DRAINAGE SUMMARY

PROJECT : INTERSTATE ROUTE H-3

F. A. I. PROJECT NO: 1 - H-3-(150)

STATE OF HAWAII DEPARTMENT OF TRANSPORTATION HIGHWAYS DIVISION
DRAINAGE PLAN
INTERSTATE ROUTE H-3 F.A.I. PROJ. NO. I-H3-1(50)
SCALE: 1" = 40' DATE: JUL., 1988
SHEET No. H8 OF 54 SHEETS

DRAINAGE PLAN
PLAN AND PROFILE
STA. 449+60
INTERSTATE ROUTE H-3
F.A.I. PROJ. NO. I-H3-1(50)
SCALE: AS NOTED
DATE: JUL., 1988
SHEET No. H24 OF 54 SHEETS

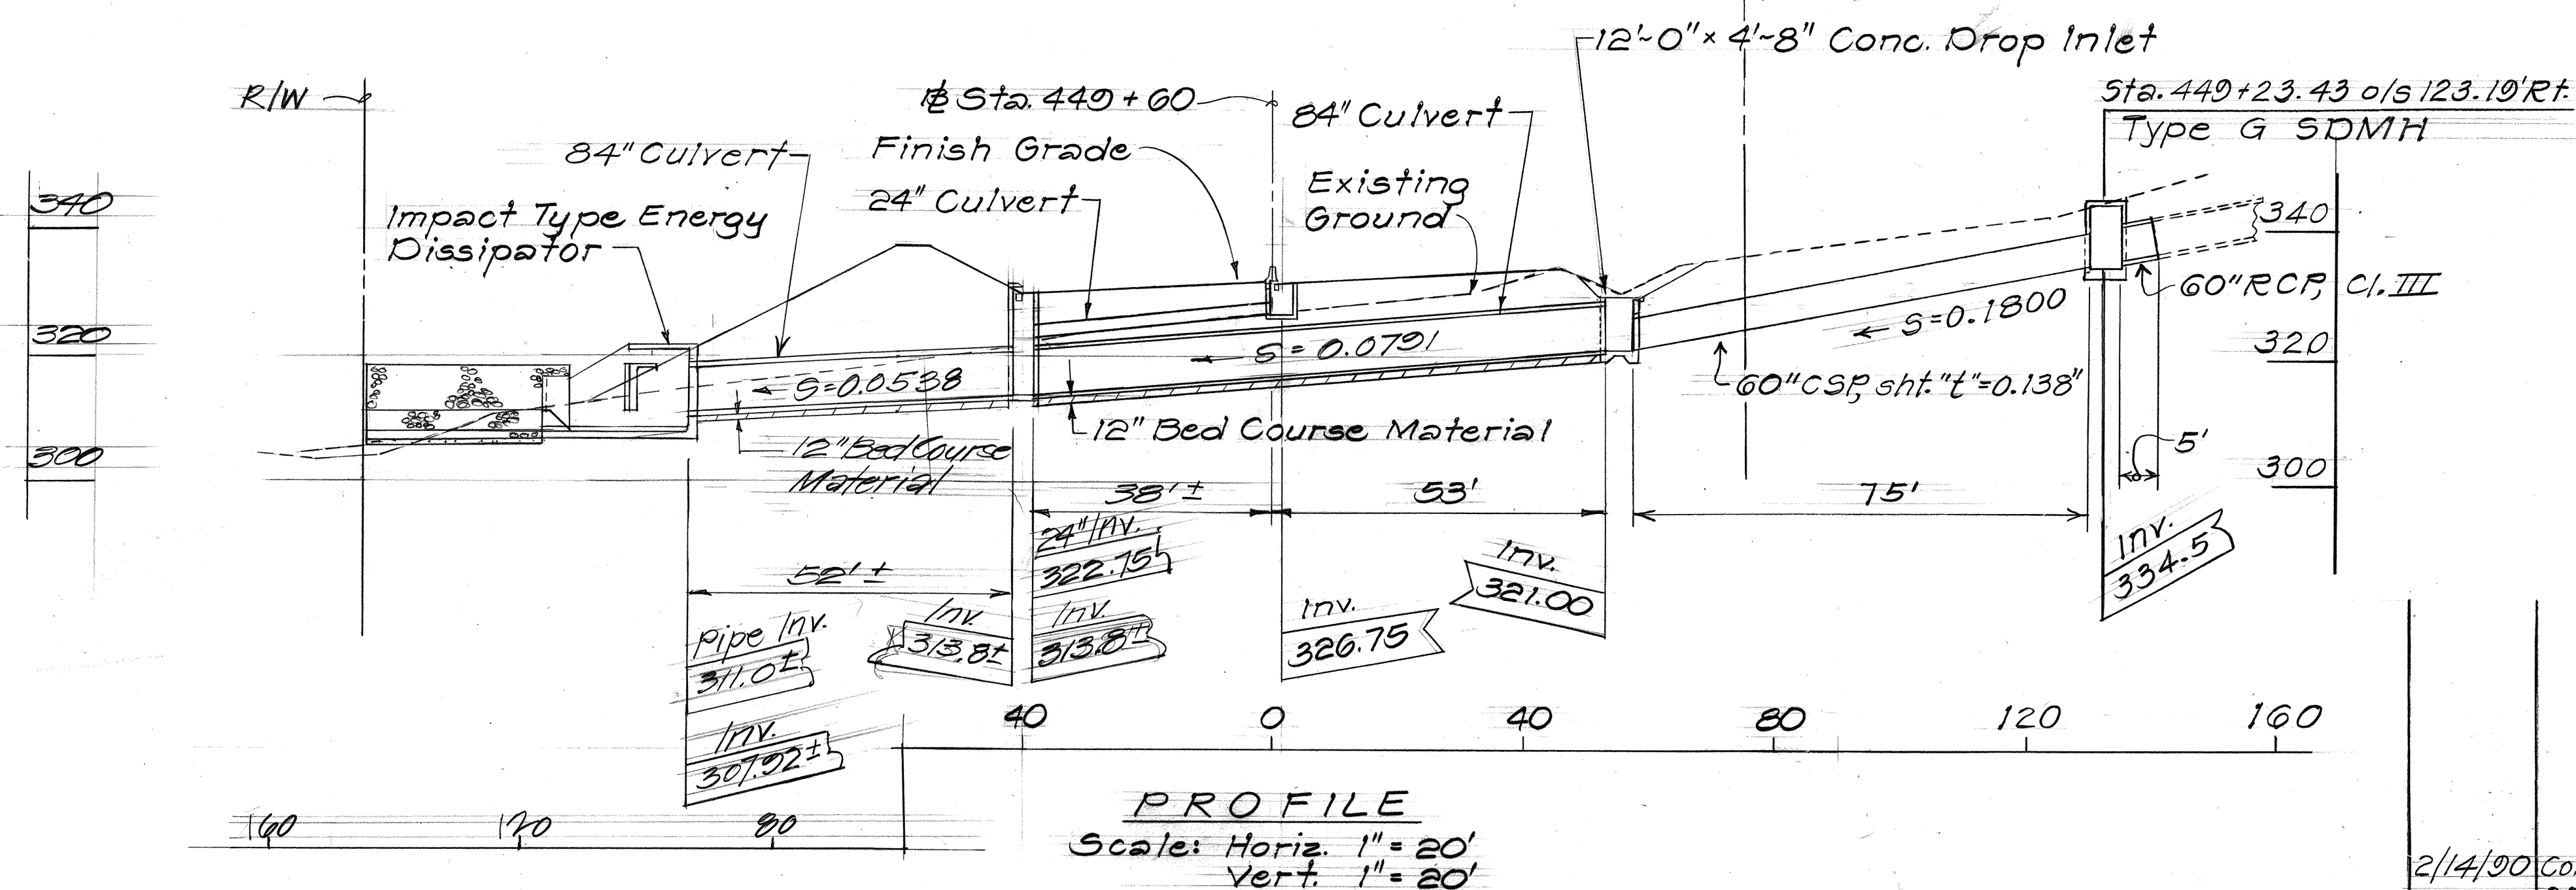
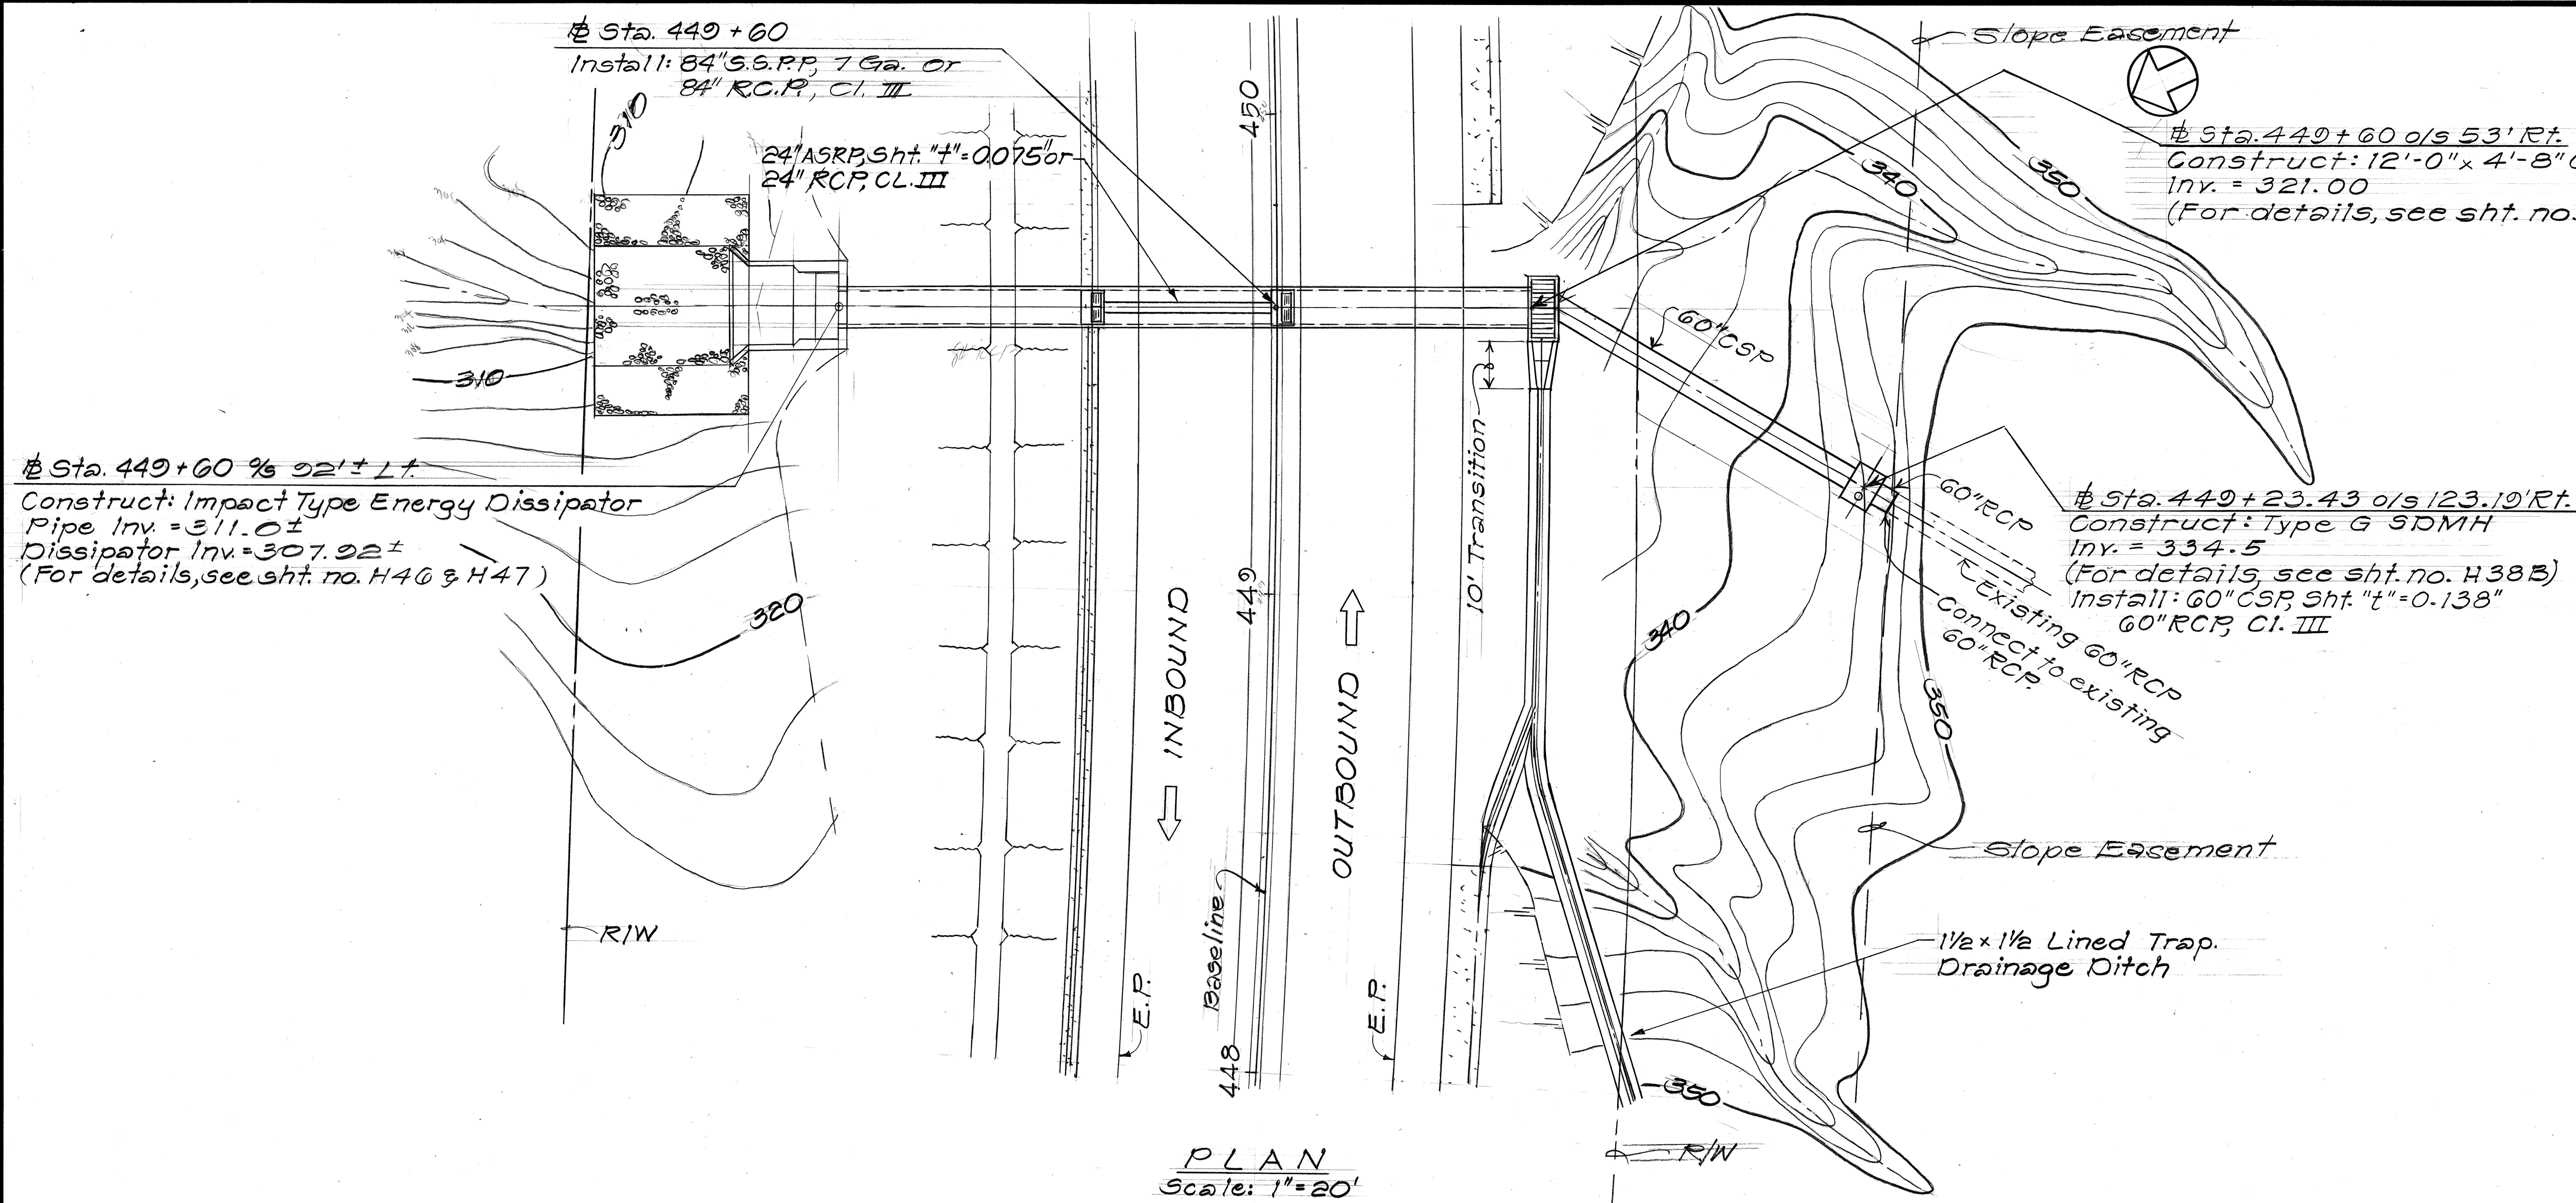
2/14/90 Connect 60" culvert to 12'-0"x4'-8" C.D.I. Replace 3'x5' Trap. Drainage Ditch w/1 1/2 x 1 1/2 Lined Trap. Drainage Ditch.

DRAINAGE PLAN
PLAN AND PROFILE
STA. 485+68

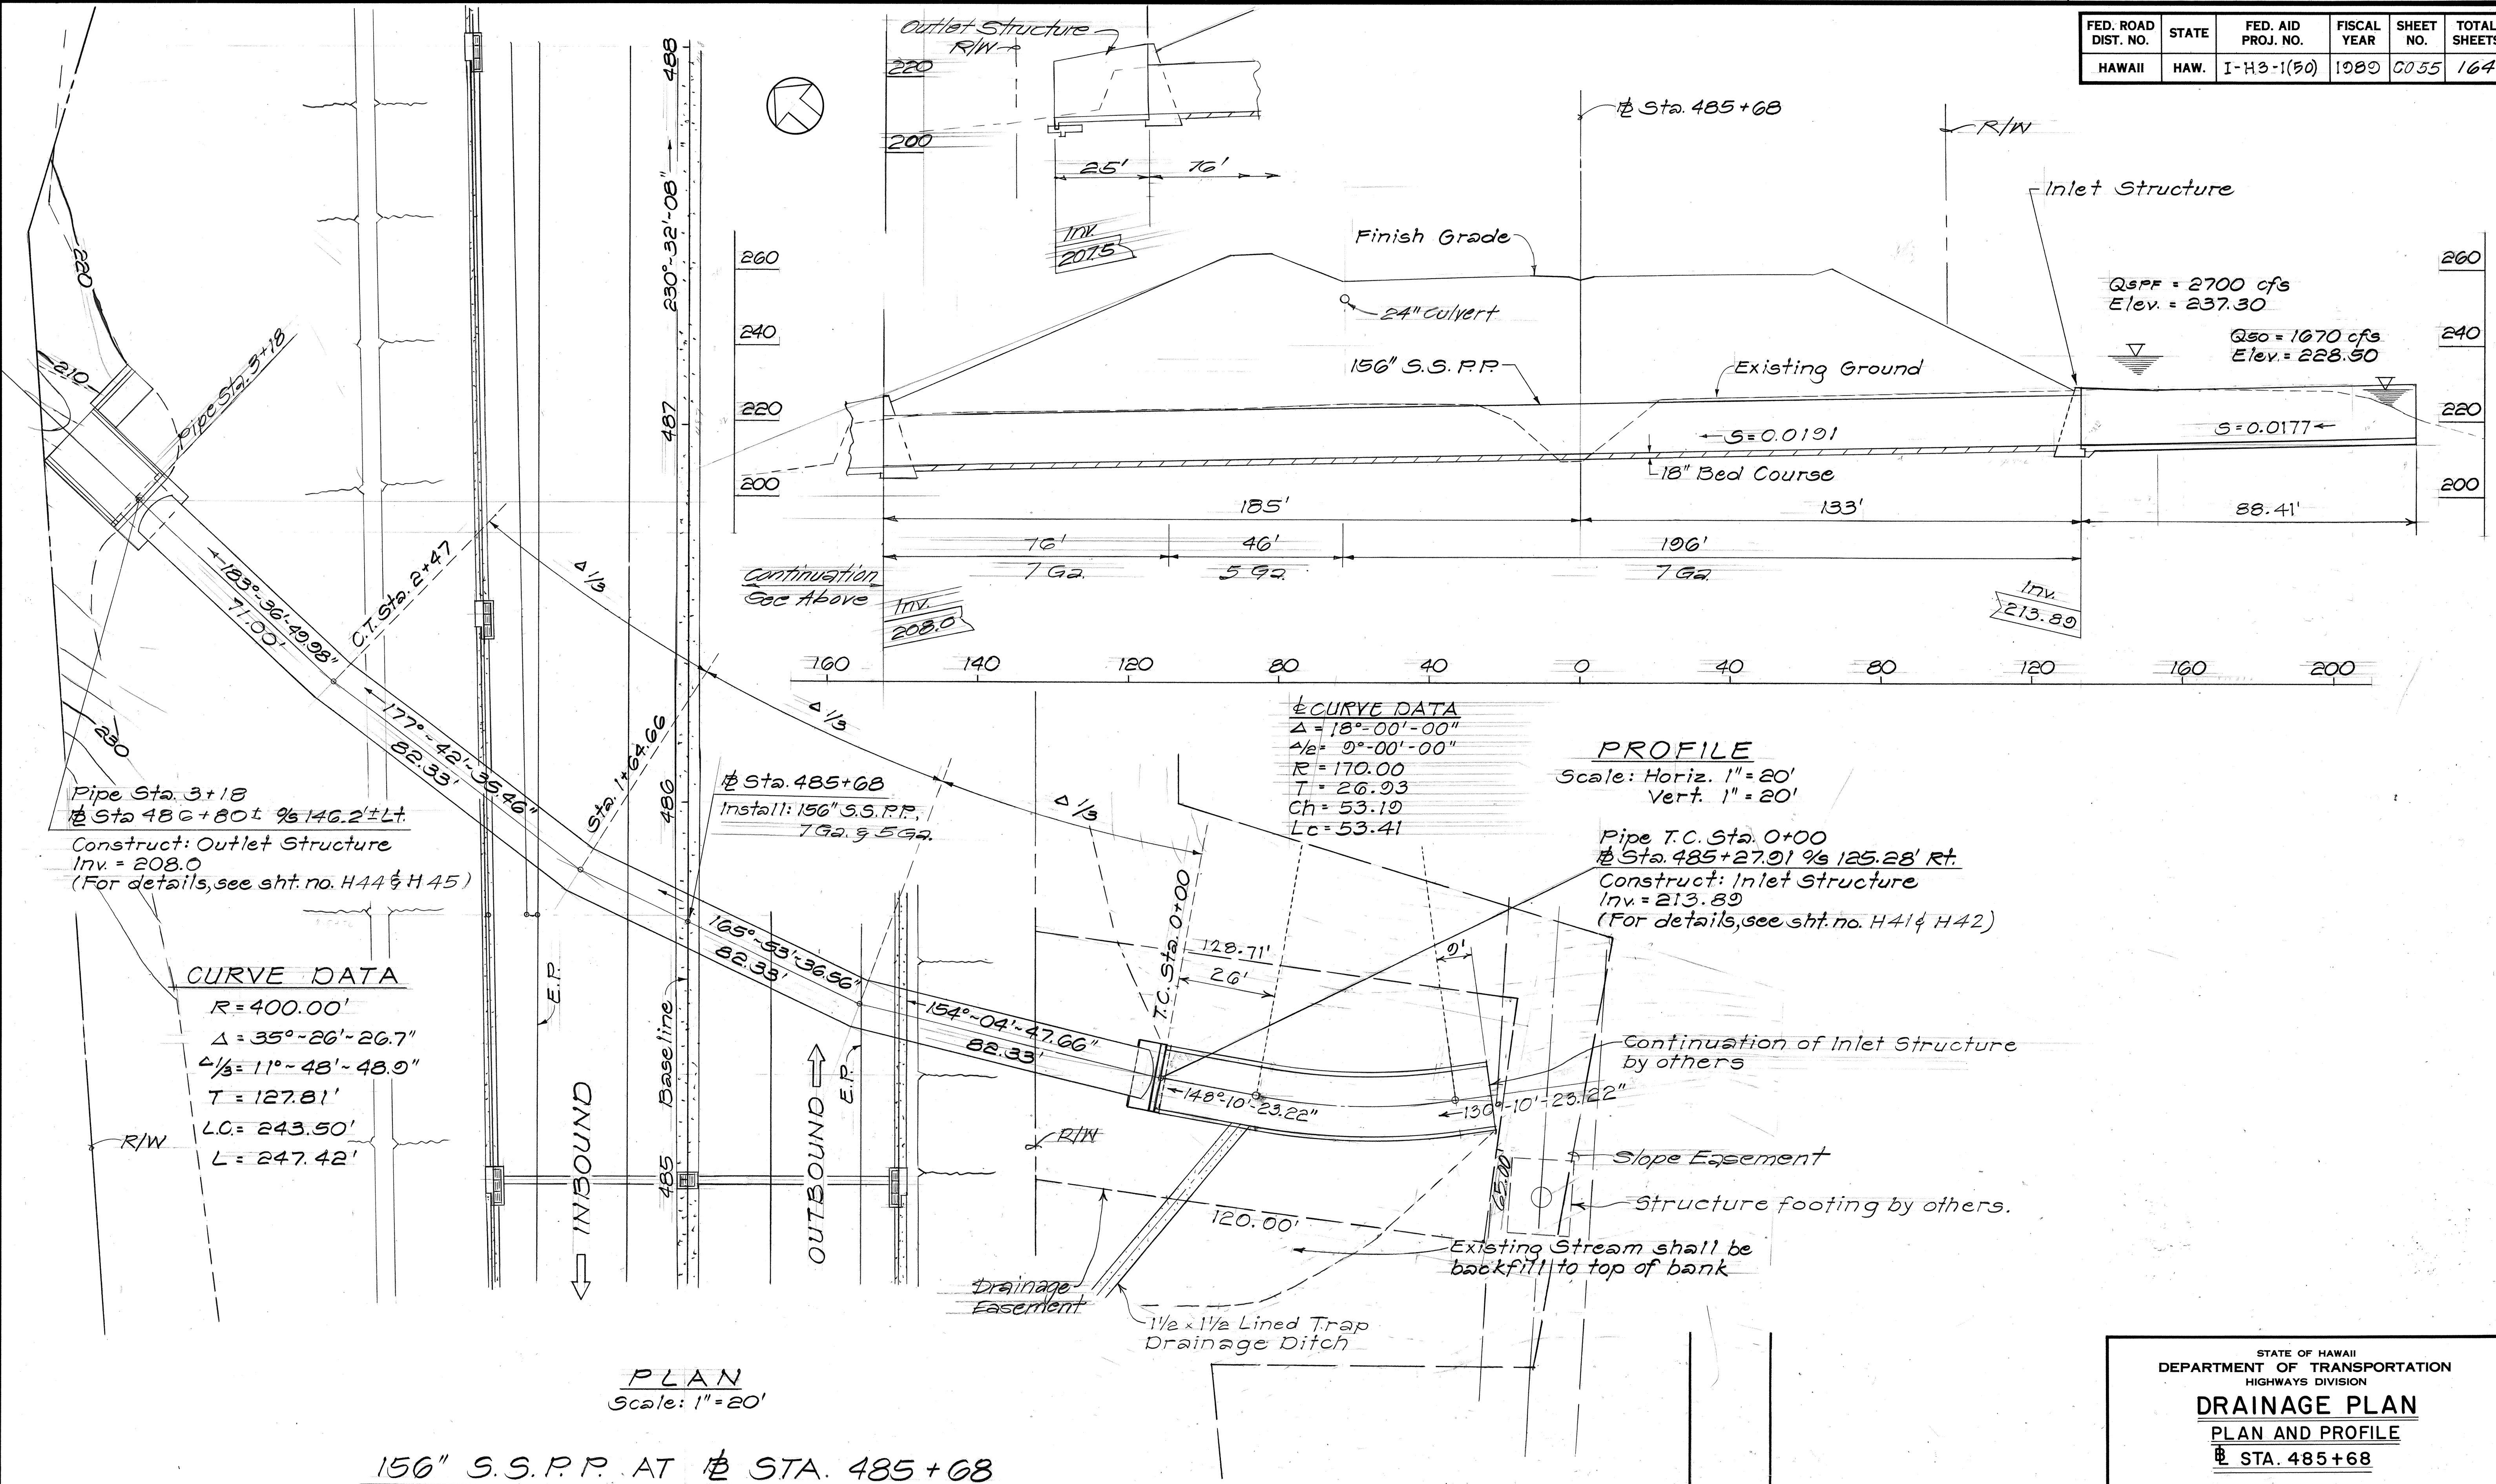
6/12/90	Revised Inlet Structure design.
DATE	REVISION
